#### ADDENDUM NO. 7

**June 6, 2022**

# LIBERTY INTERMEDIATE SCHOOL ADDITIONS AND RENOVATIONS

This Addendum consists of Pages ADD 7-1 through ADD 7-4 and attached Addendum No. 7 from Gibraltar Design dated June 6, 2022 and consisting of 5 pages and 75 drawings.

EP102

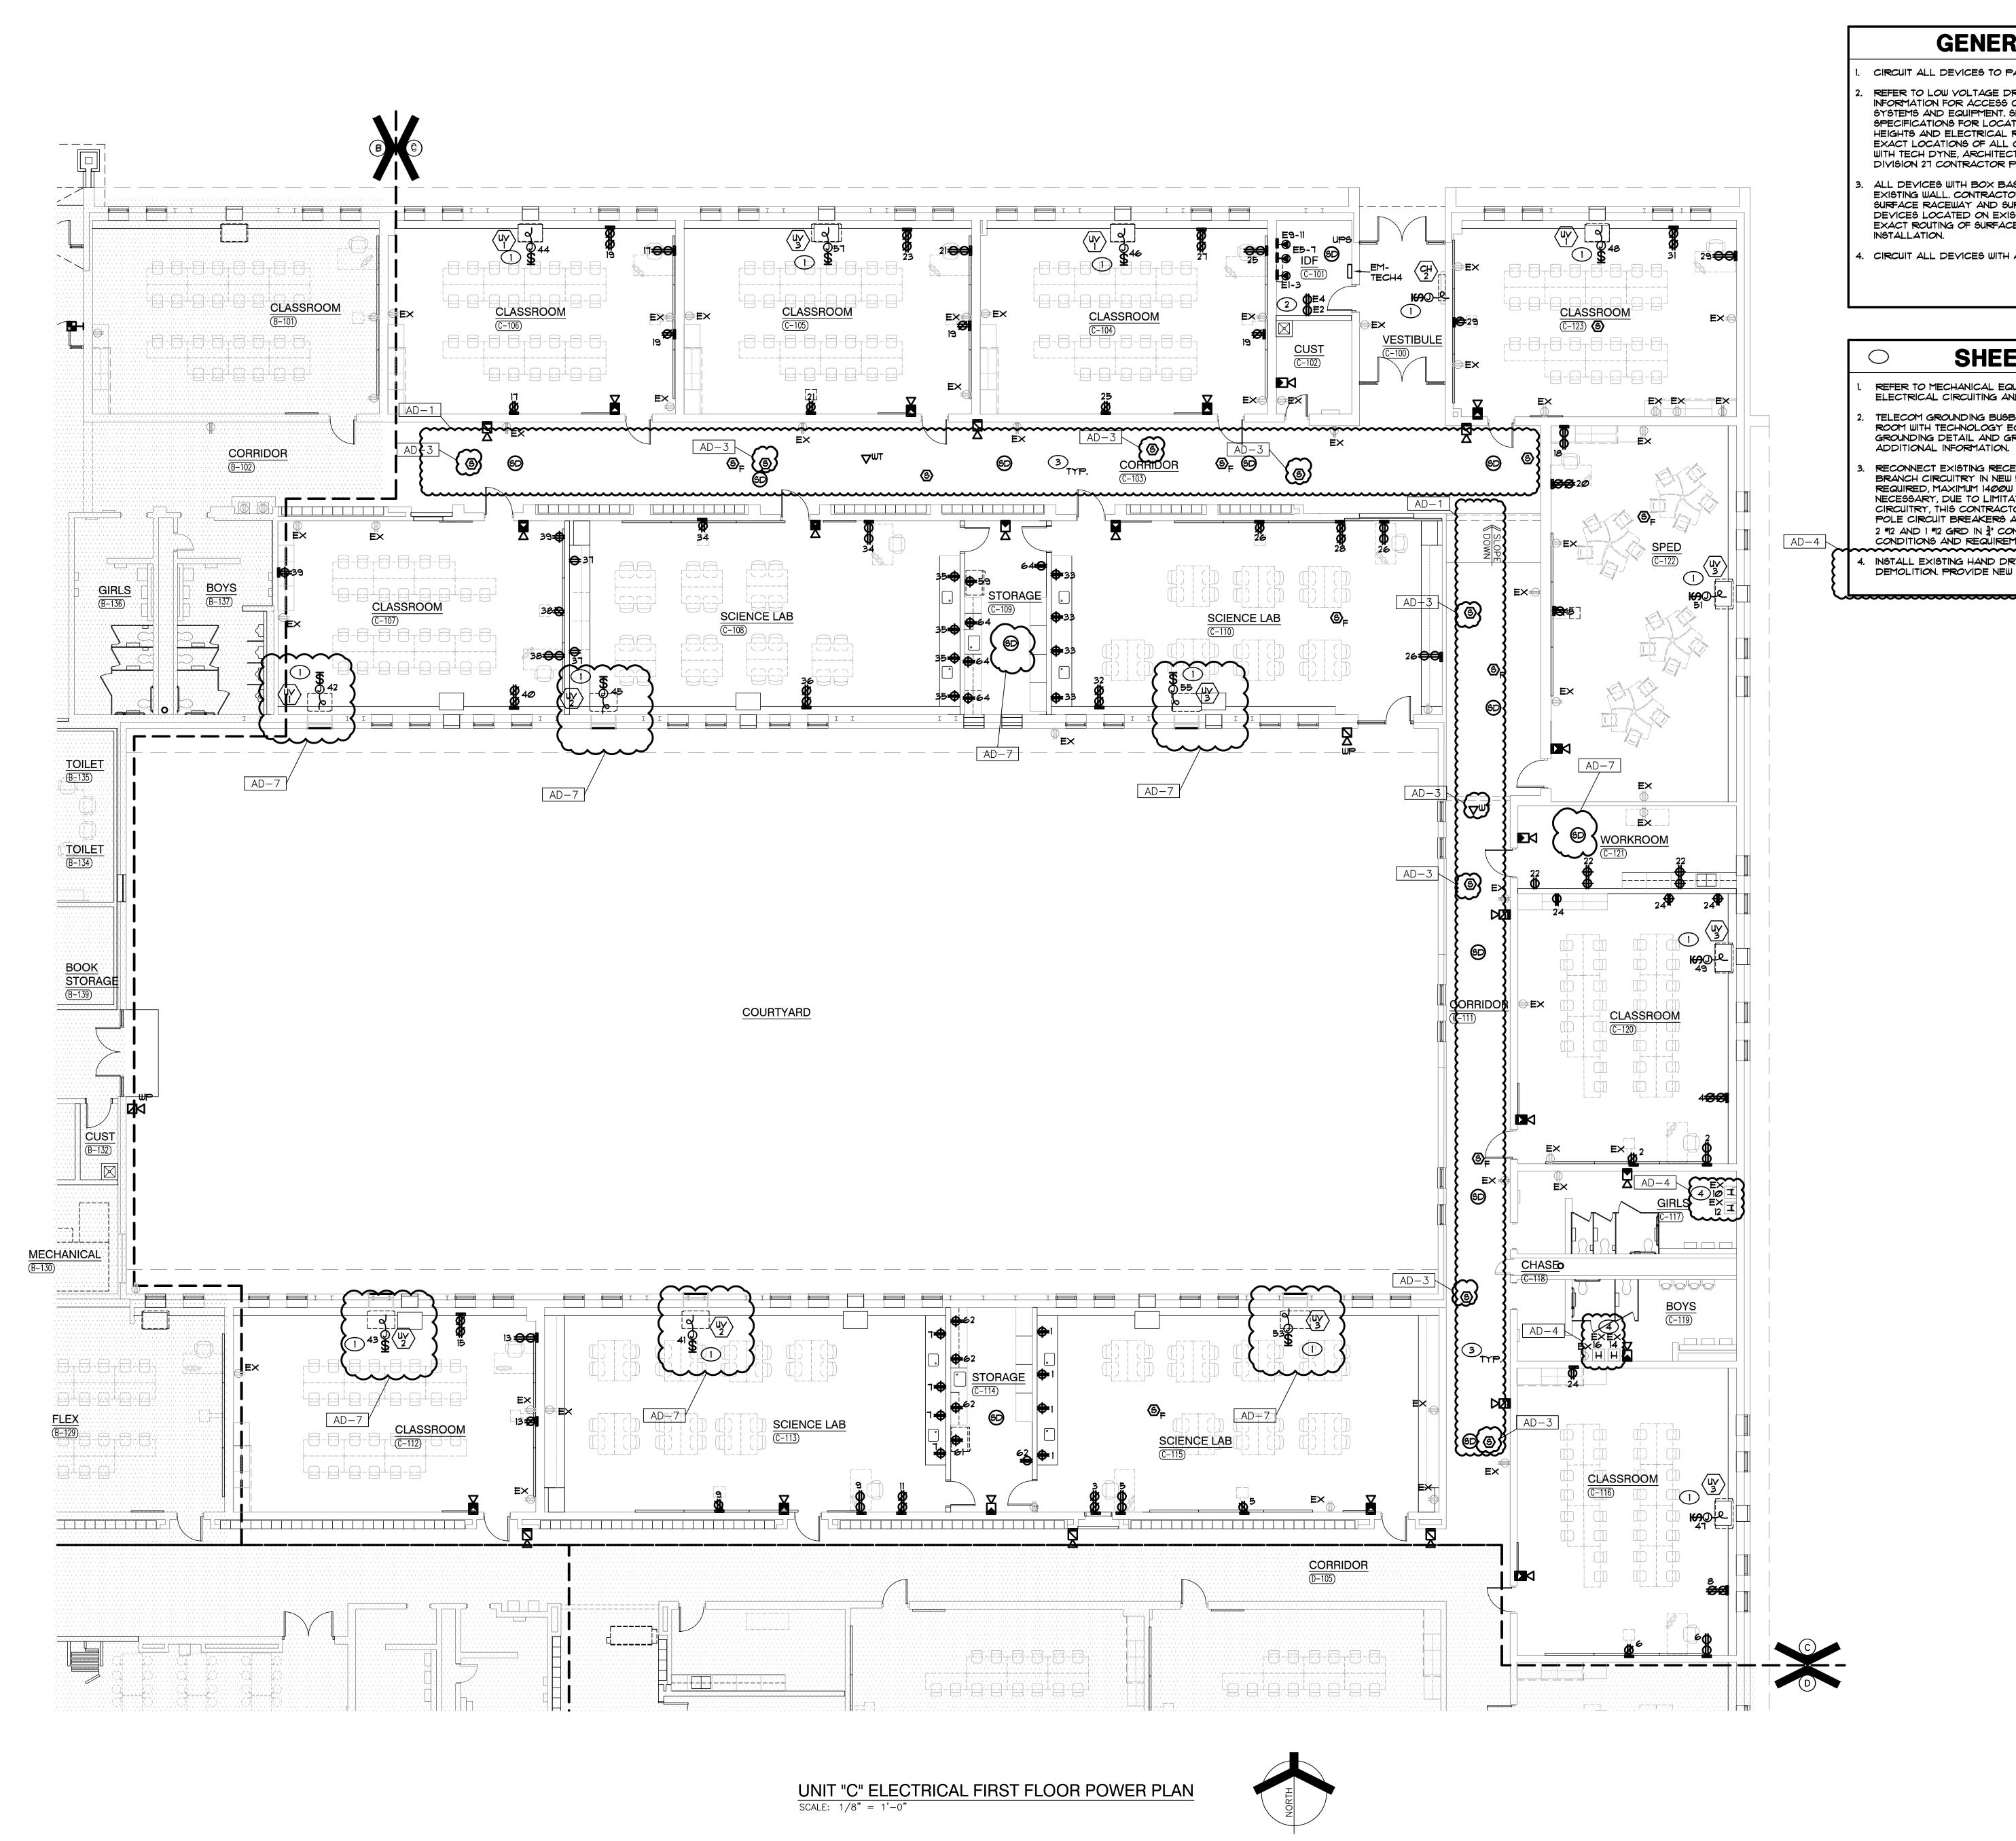
- A. Refer to revised full-size drawing included in this Addendum, for the following revisions:
  - 1. Revise Unit Ventilator location in Flex B-129.

SHEET EP103

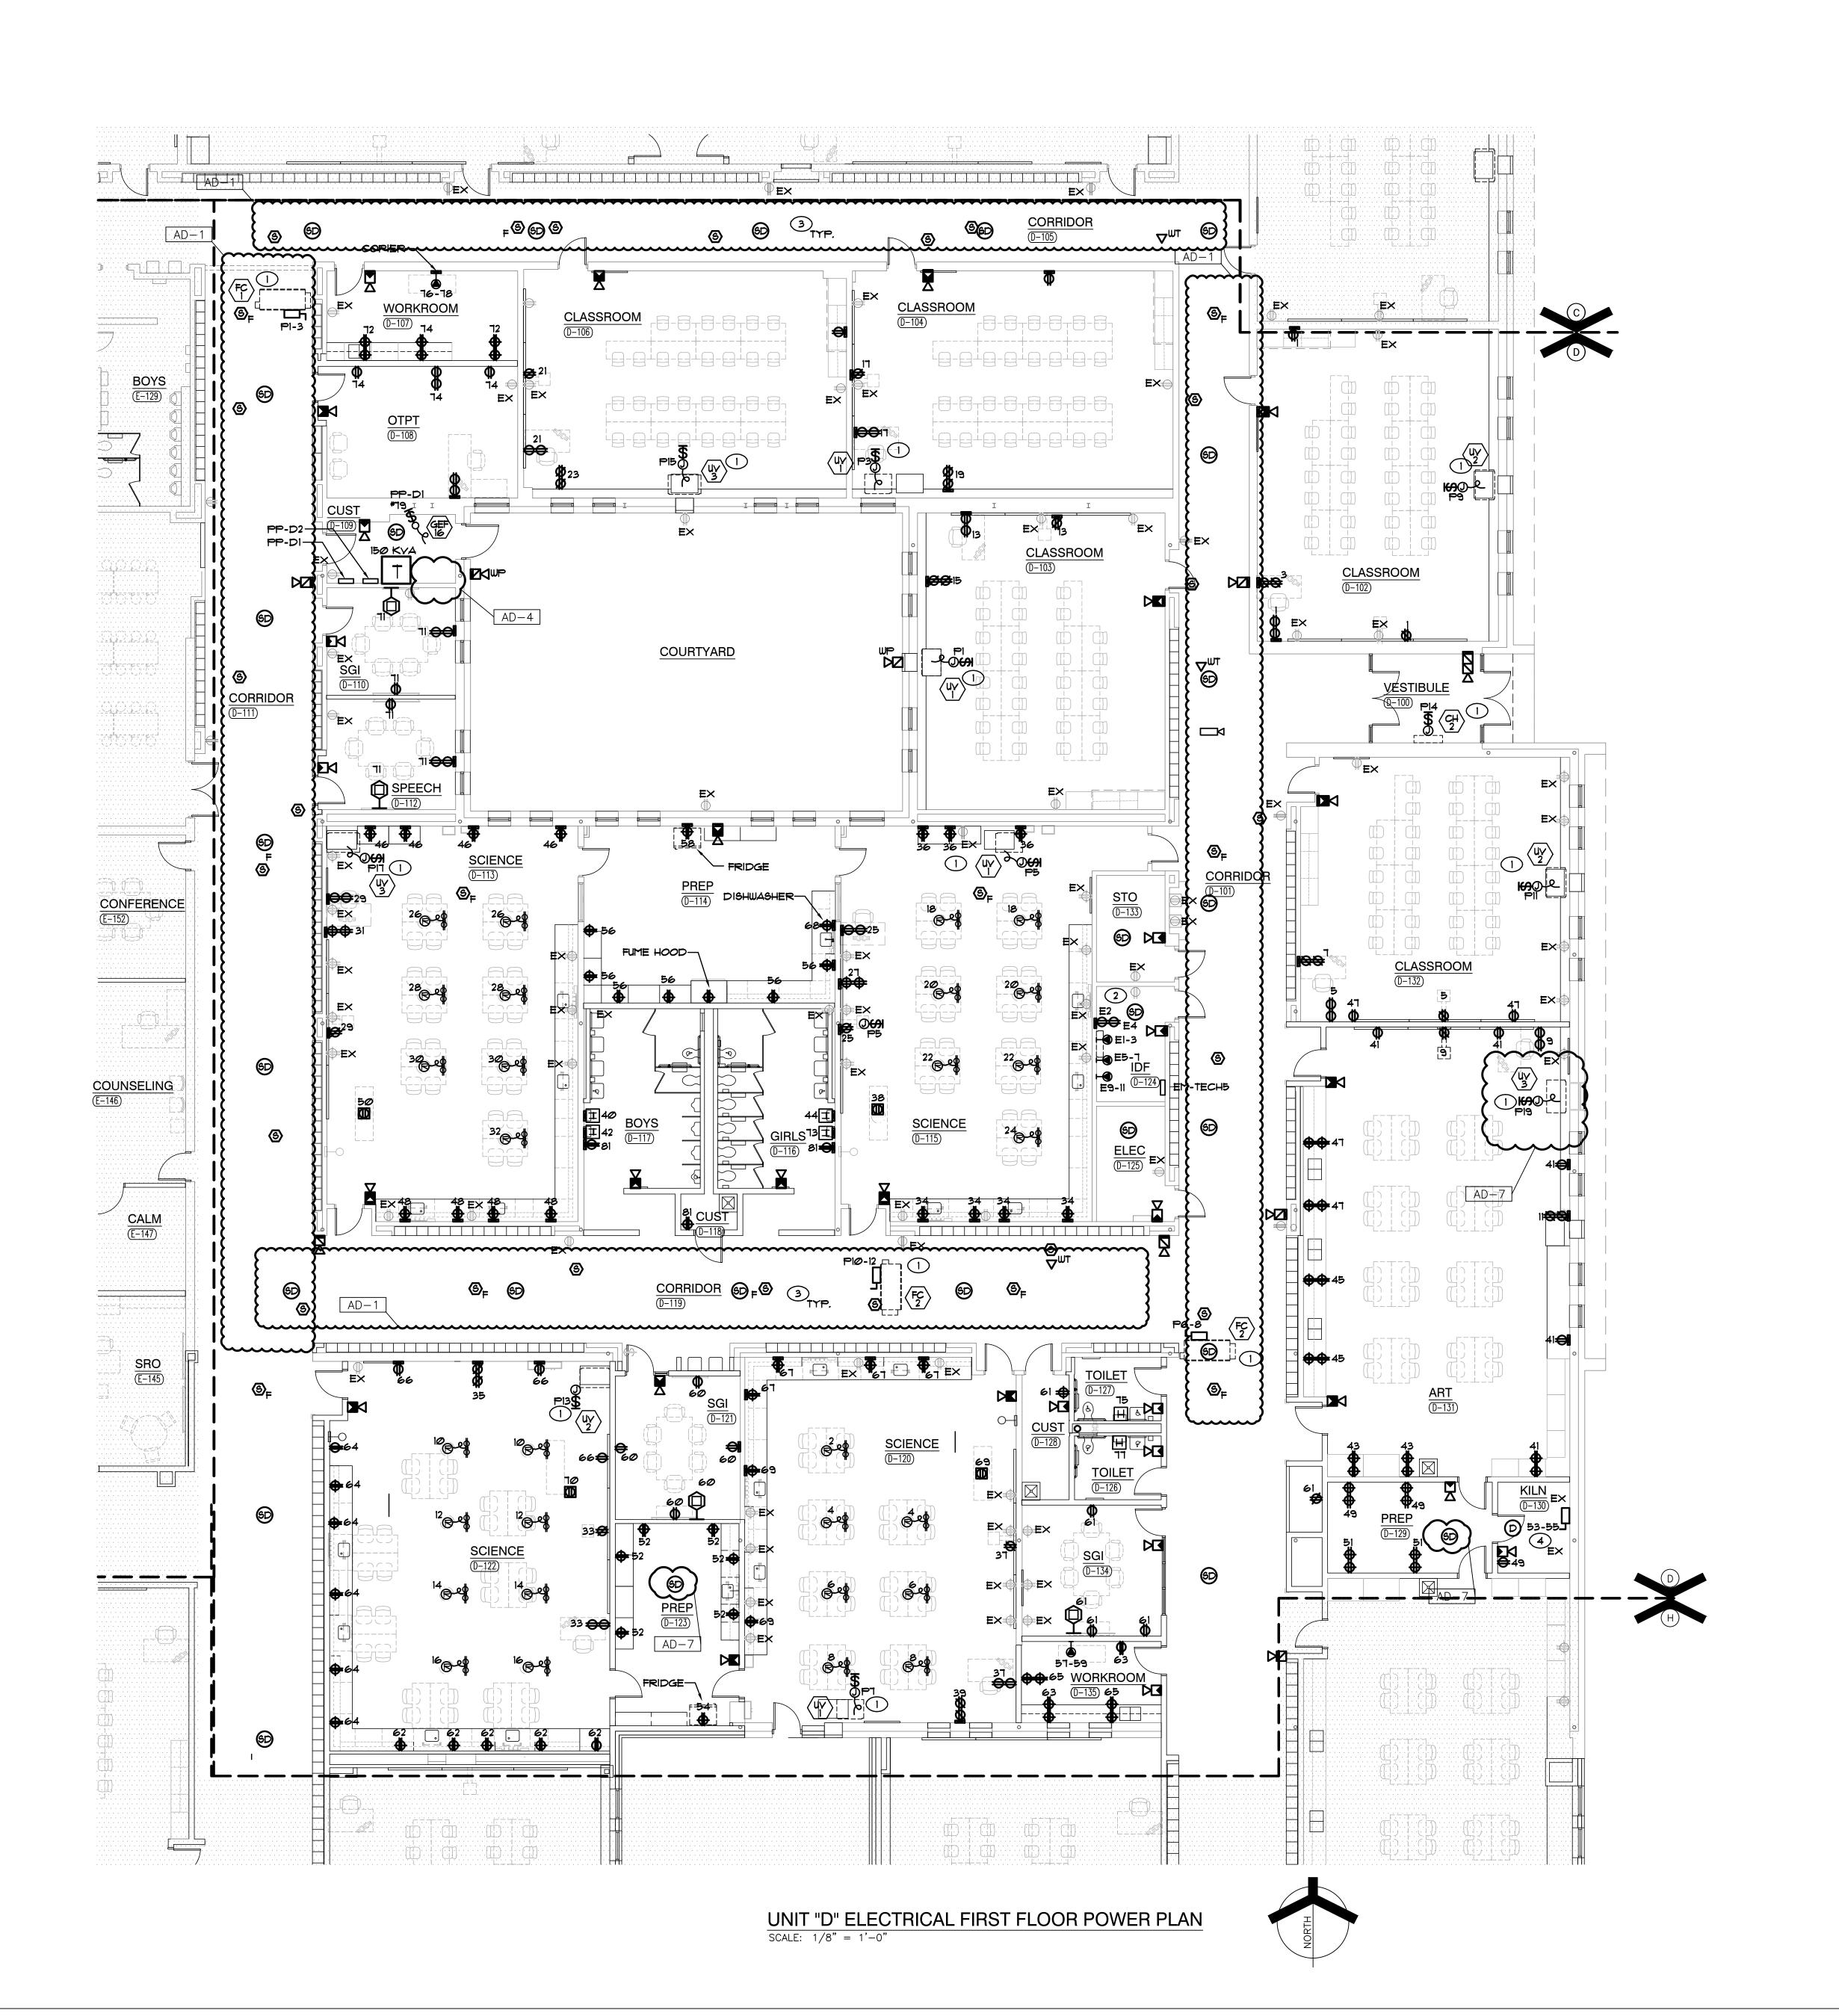
- A. Refer to revised full-size drawing included in this Addendum, for the following revisions:
  - Revise Unit Ventilator location in Classrooms C-107, C-108, C-110, C-112, C-113, & C-115.
  - 2. Add smoke detector to Storage C-109 & C-121.

EP104

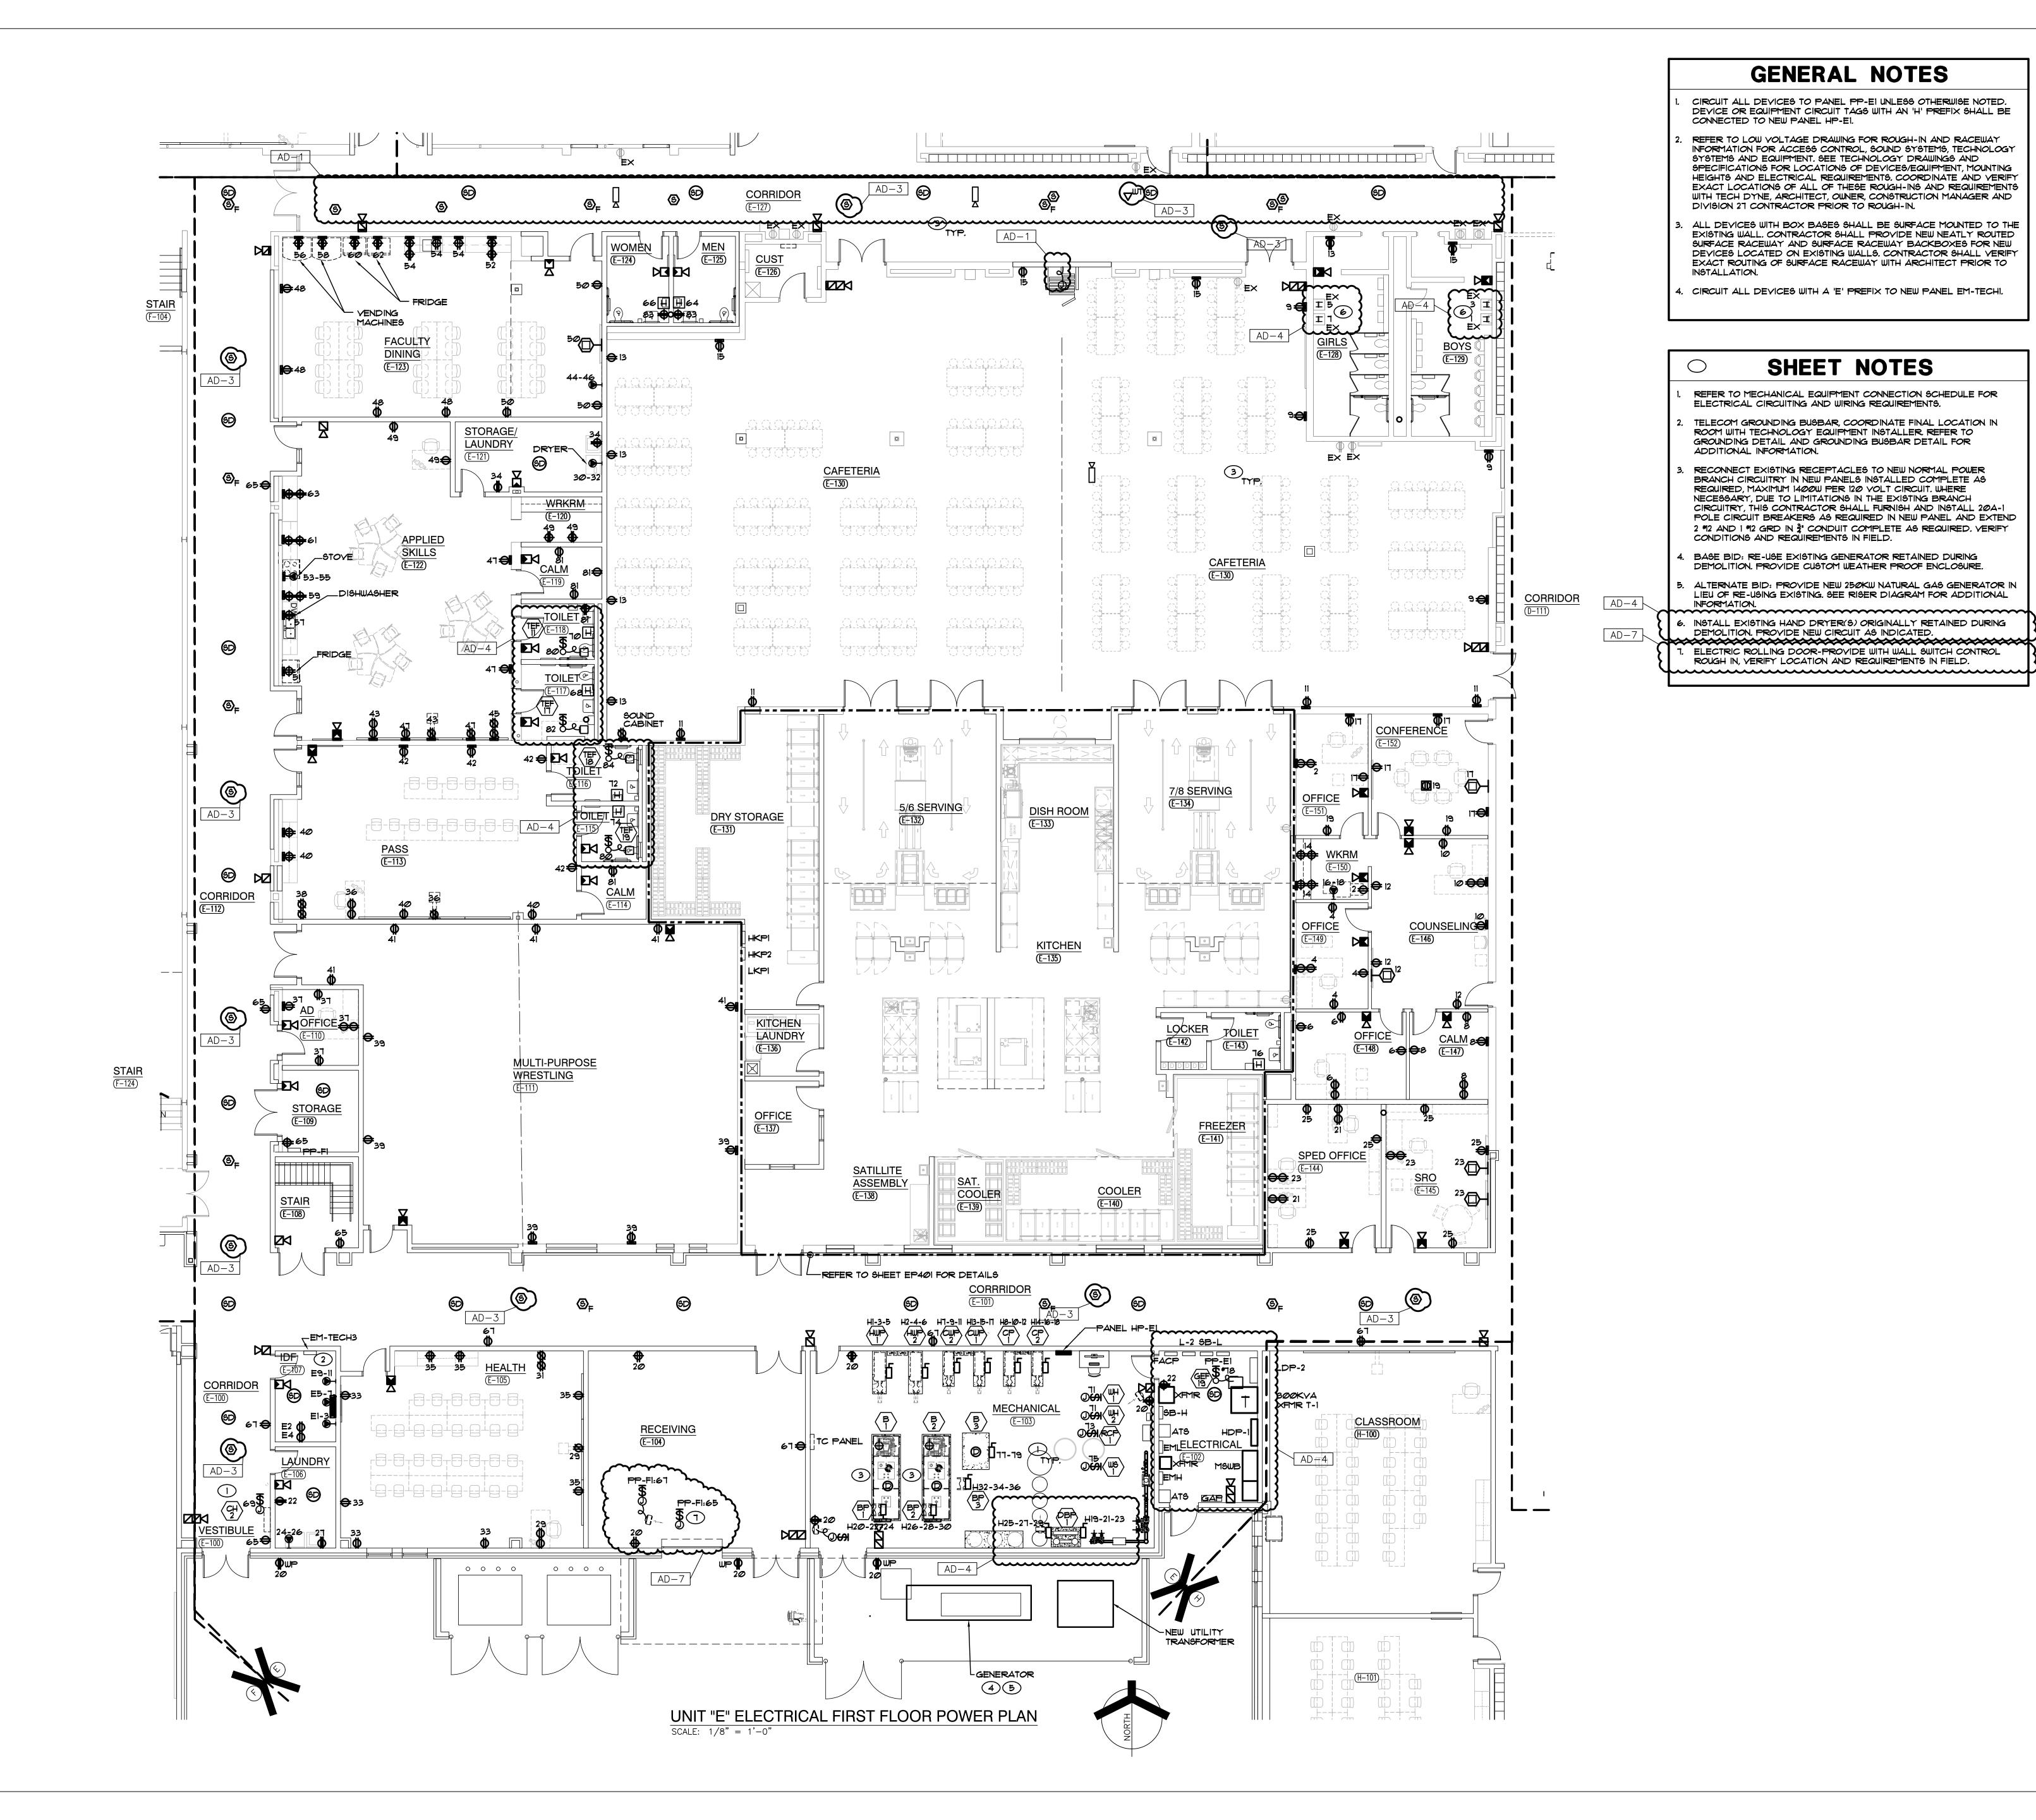
- A. Refer to revised full-size drawing included in this Addendum, for the following revisions:
  - 1. Revise Unit Ventilator location in Art D-131.
  - 2. Add smoke detector to D-123 & D-129.
